PROPOSED FIRST FLOOR PLAN

## **NON - MATERIAL AMENDMENT**

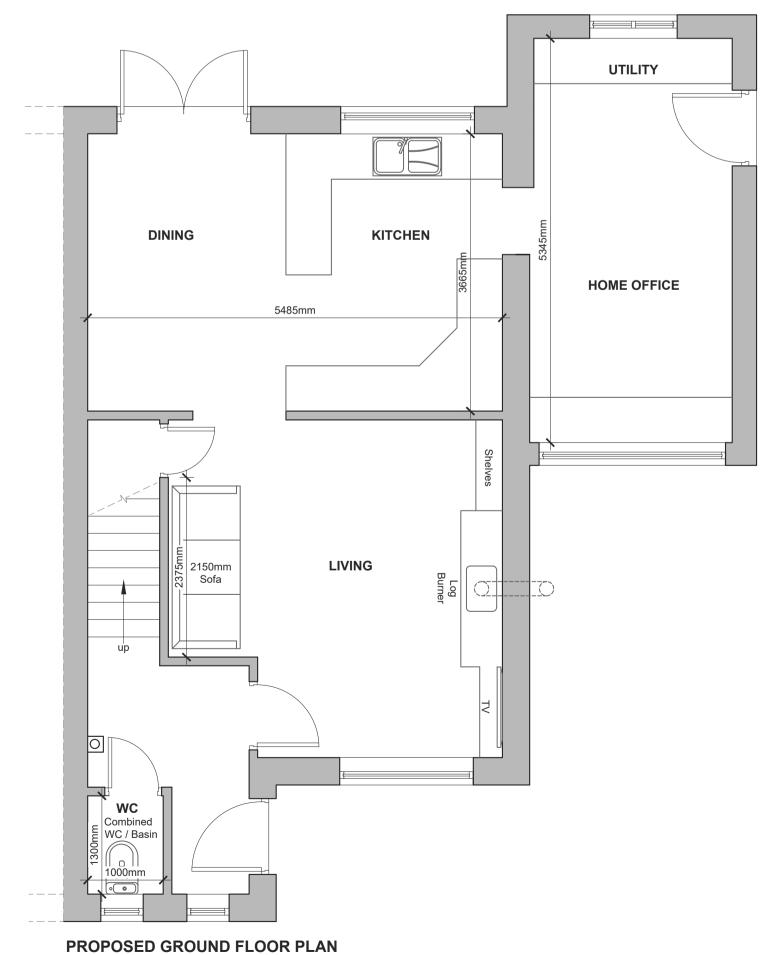
- 1/. Proposed French doors to the North West Elevation omitted from design and replaced with a window
- 2/. Existing window in South East Elevation to be replaced with a single pane unit
- 3/. Window to replace Garage door to be altered
- 4/. Stone infill below window to replace garage door to be omitted and replaced with blockwork with a white rendered finish.
